# JOURNAL OF COASTAL AND HYDRAULIC STRUCTURES

Review and rebuttal of the paper

## CFD modeling of flow and local scour around submerged bridge decks

G. Fleit et al.

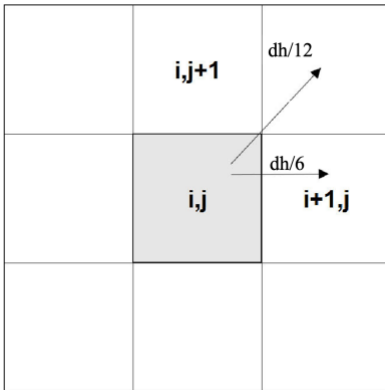
**Reviewer comment/question:** Does the redistribution also go over the corners not only over the faces? Or don't you have cubic cells? I would expect 6 neighboring cells for a cube.

**Author reply:** On point remark. Whenever the bed slope exceeds the angle of repose of the bed material, the slope of the concerned bed cell is readjusted by redistributing the volume of sediment in all eight neighboring cells (horizontal neighbors, as presented in the figure below, which is a top view). During the redistribution, the heights of the direct neighbor cells are increased/decreased by  $dh/6$ , where  $dh$  is the height difference between the adjacent cells, while the height of the concerned is decreased/increased by the same amount. Same approach is applied for the diagonal cells, only the value of alteration is now  $dh/12$ . The process is continued iteratively until the bed slope becomes equal to the angle of repose of the bed material. This is the case for truly 3D cases. However, in case of the 2DV simulations used in this study, there are only two horizontal neighboring cells, that is the redistribution is only performed for those ones using the same factors ( $dh/6$ ). The related section has been rephrased to clarify this issue.
